AMENDMENT OF SOLICITATION/MODIFICATION OF CONTRACT

ITEM NO. (A)	SUPPLIES/SERVICES (B)	QUANTITY (C)	UNIT (D)	UNIT PRICE (E)	AMOUNT (F)
	HVAC REPAIR JV RESOURCE, JORDAN VALLEY OREGON The purpose of this amendment is to answer questions submitted by interested contractors. Period of Performance: 10/30/2026 to 11/30/2026

140L4326Q0127 HVAC Repair
Jordon Valley, Oregon

Questions and Answers

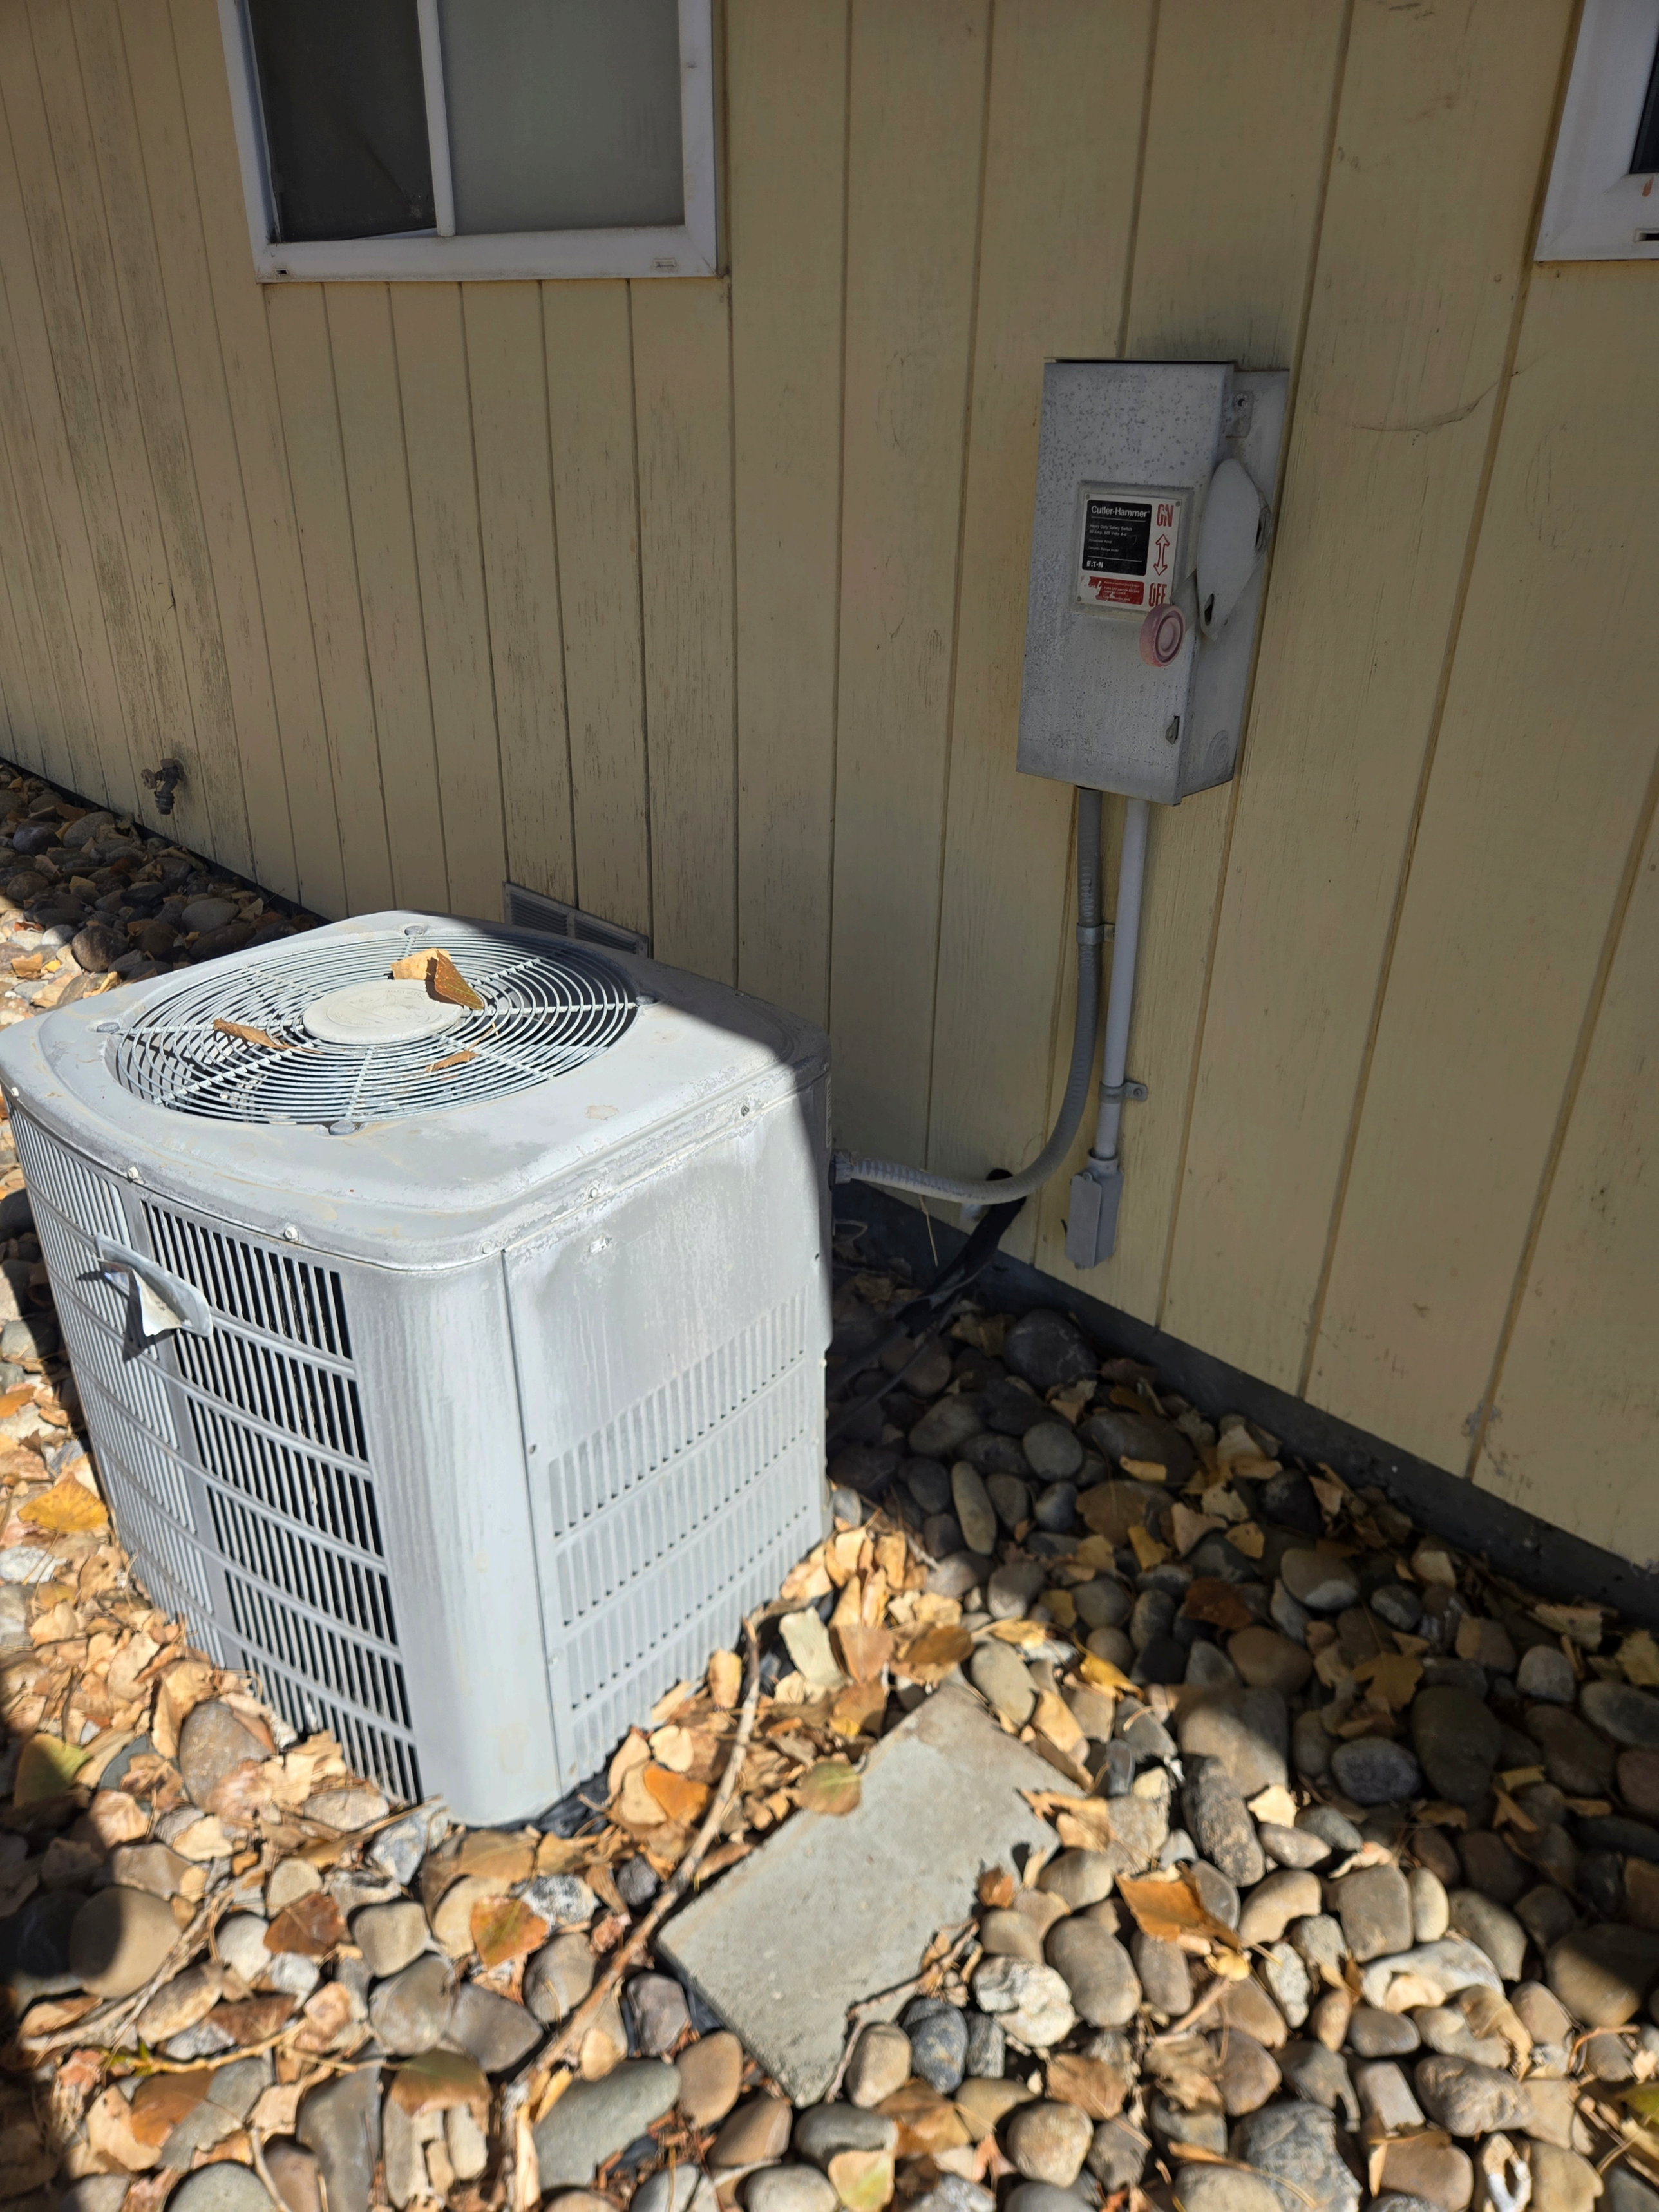
a. Yes, new R-32 refrigerant is acceptable and expected.
8. Existing Equipment Data: Can the Government provide the make, model, and serial numbers of the existing condenser and air handler, along with photos of the indoor unit location and electrical disconnect?

13. If available, please provide the make, model, and tonnage (and nameplate airflow, if known) of the existing outdoor unit and air handler.
    a. Please see attached images.

a. Please see attached images.
9. We are considering an Idaho-licensed HVAC subcontractor for the Jordan Valley Guard Station HVAC replacement. Could you please clarify whether the subcontractor must hold an active Oregon Construction Contractors Board (CCB) license to perform this work, or whether any exemption applies because the work is being performed at a federal facility?
